STATE OF OHIO DEPARTMENT OF TRANSPORTATION

SUM-241-1.50/VAR

RESURFACING OF SUM SR 241, INCLUDES URBAN PAVING IN THE CITY OF GREEN, AND MINOR WORK TO 1 STRUCTURE.

TYPICAL	SECTION	#1 (NO C	URB, IN C	ITY OF GREEN)				
ROUTE	SL	M	LENGTH	WP				
ROUTE	FROM	ТО	(MILES)	(FEET)				
241	1.50	1.54	0.04 🗸	~30~				
241	1.79	2.55	0.76	31				
241	4.74	5.63	4.89	31				
TOTAL = 1.69 MILES								
mint !!								
				Revised

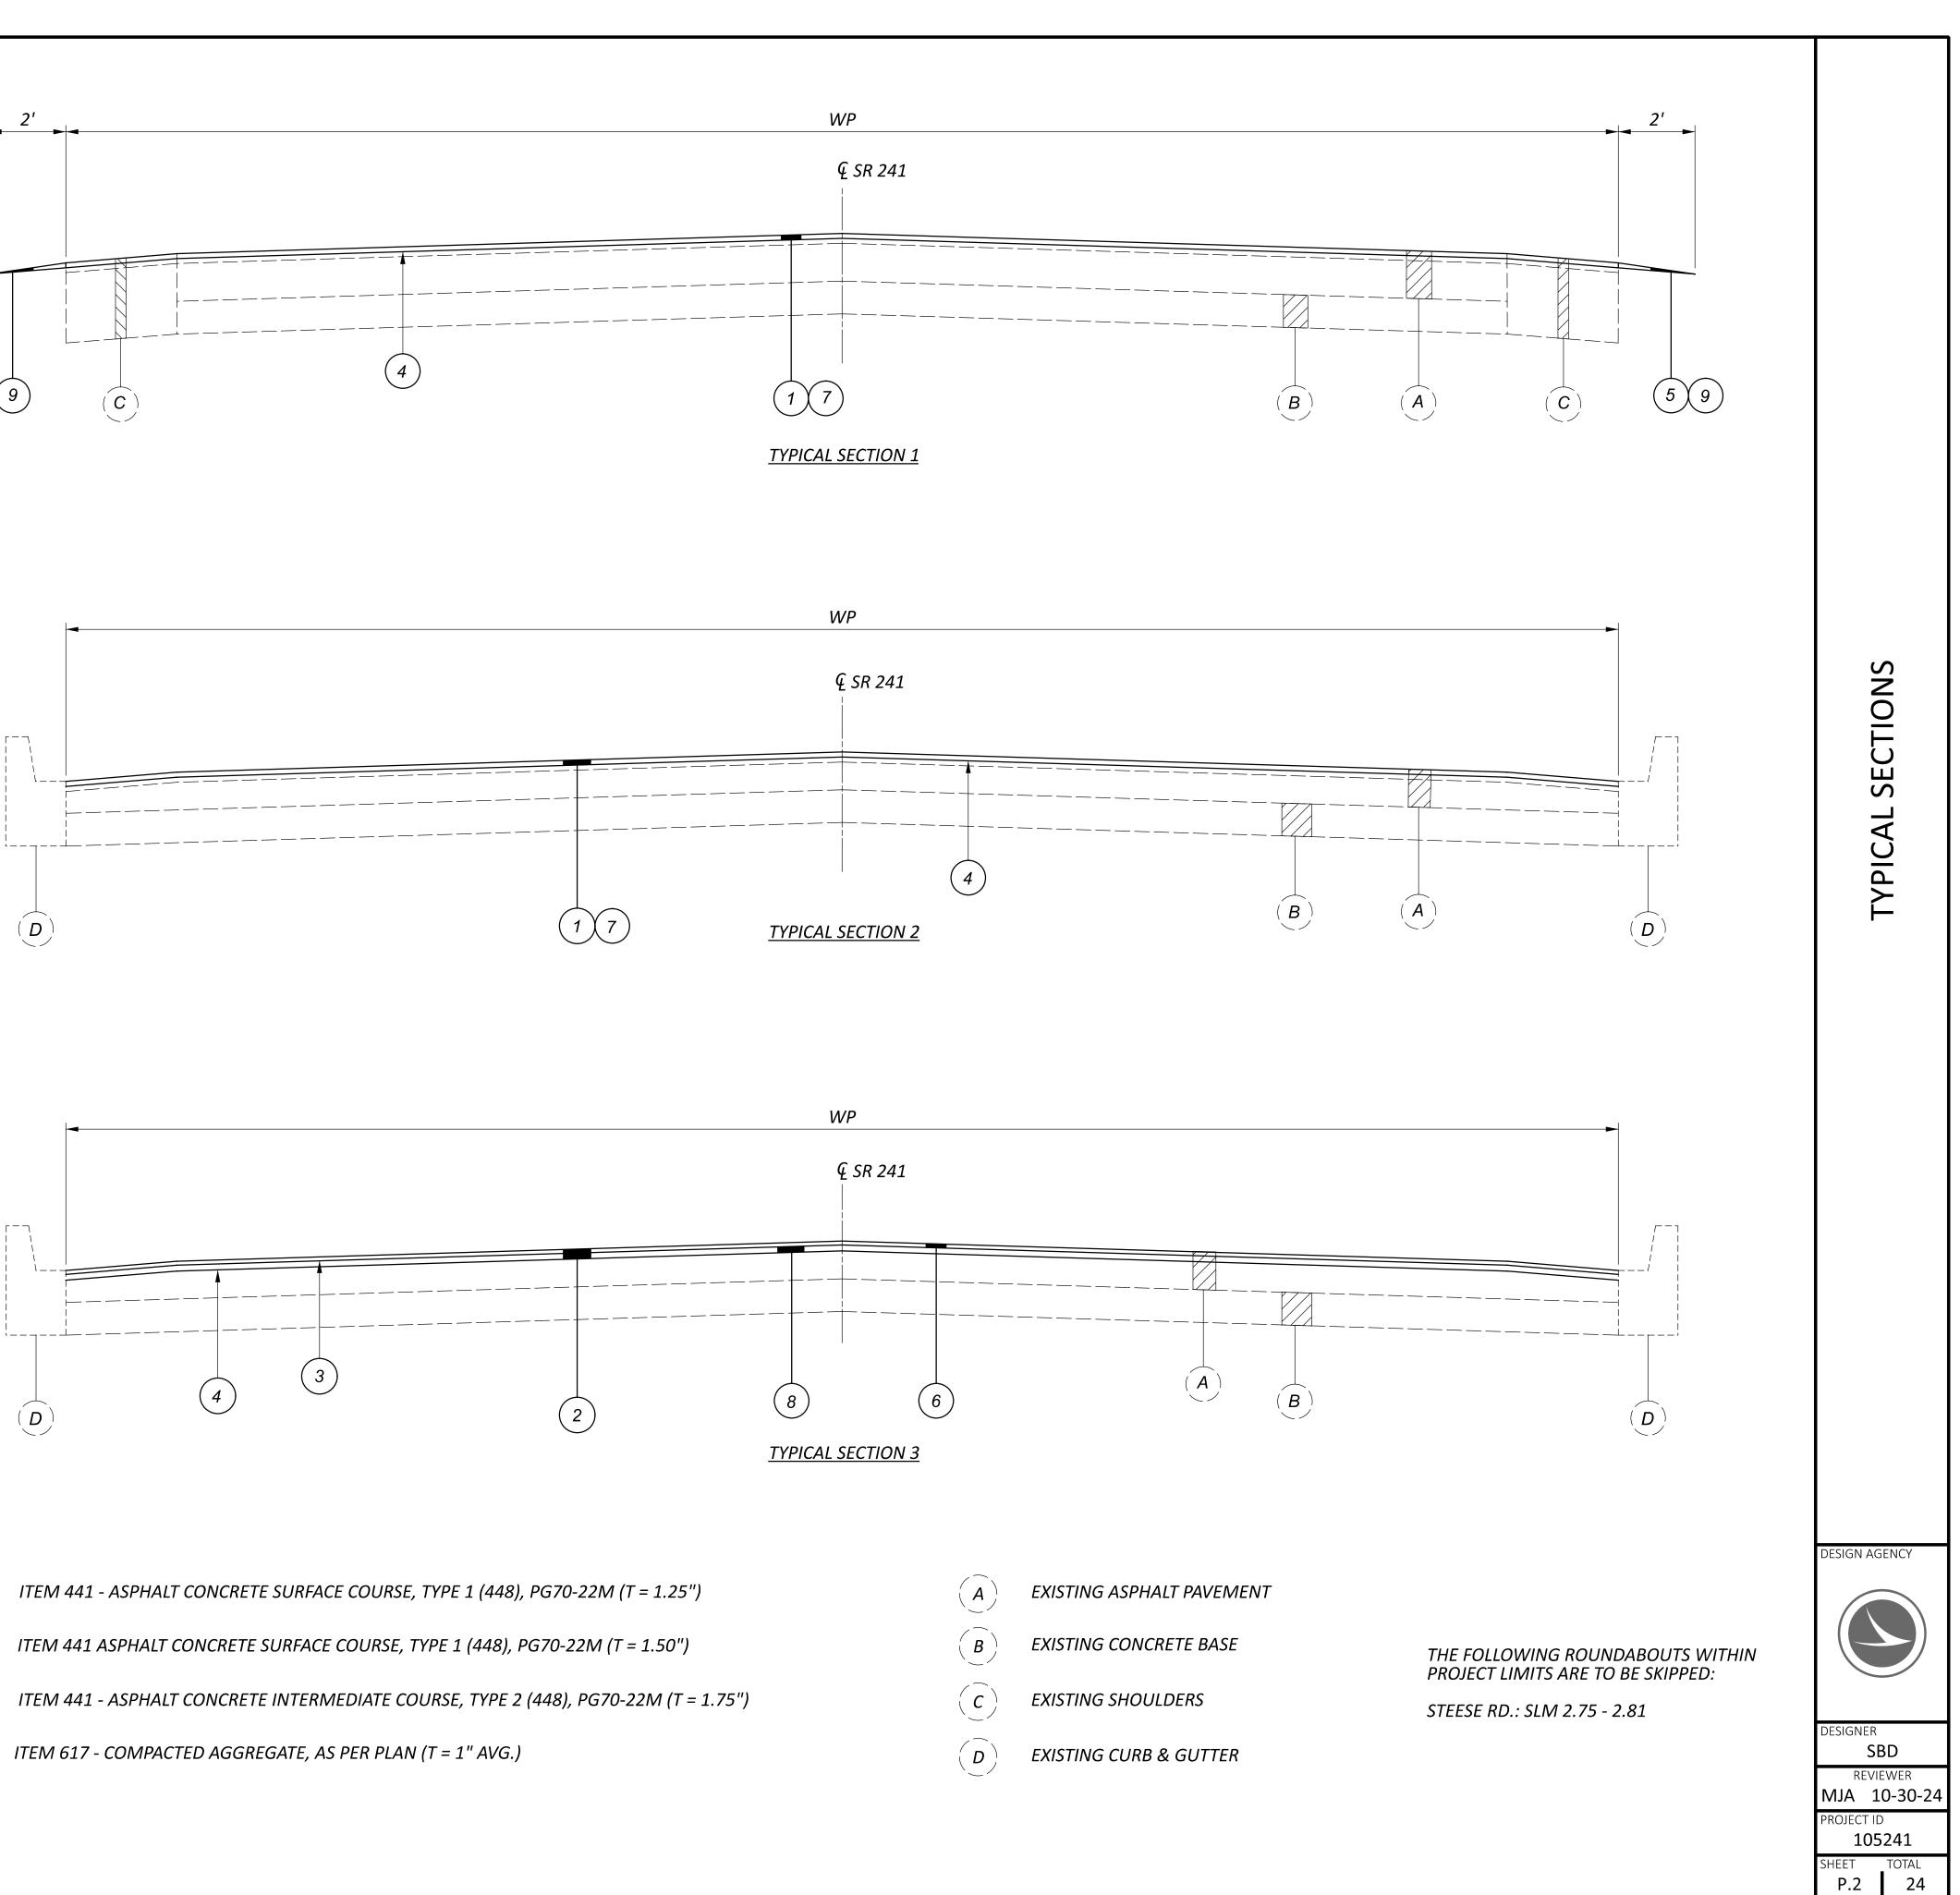
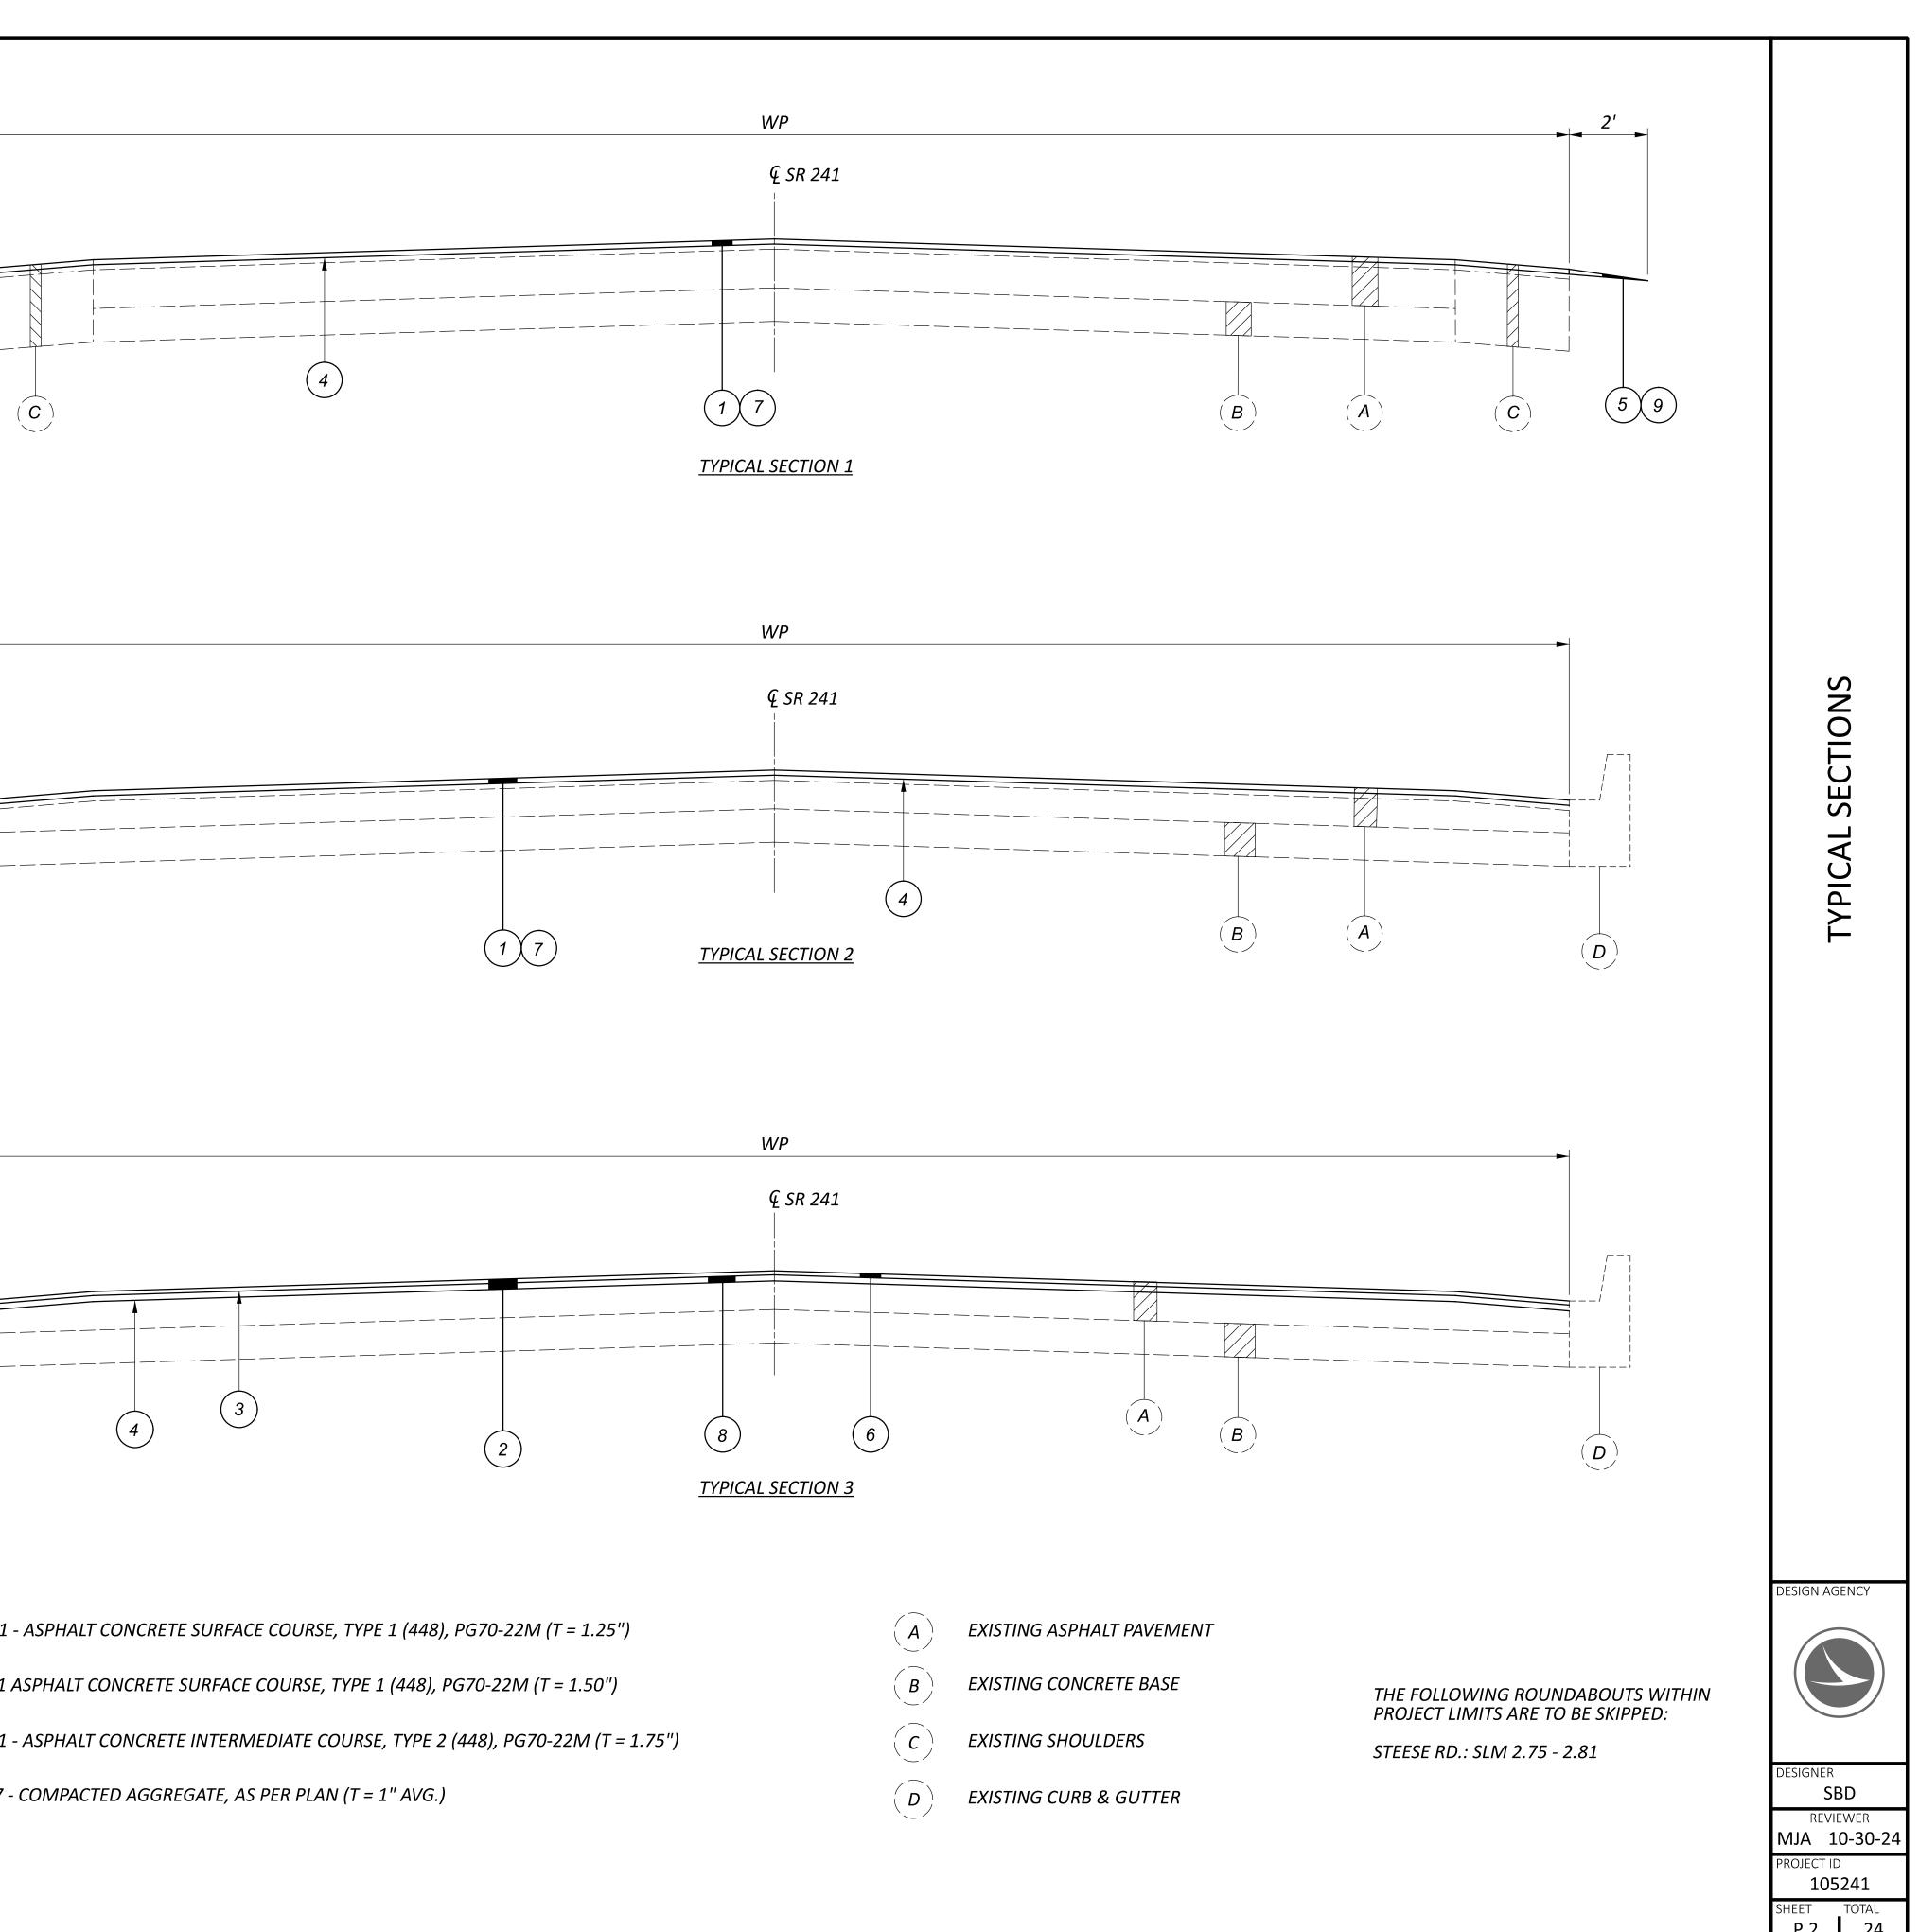
<u> </u>	Revised
	Revised
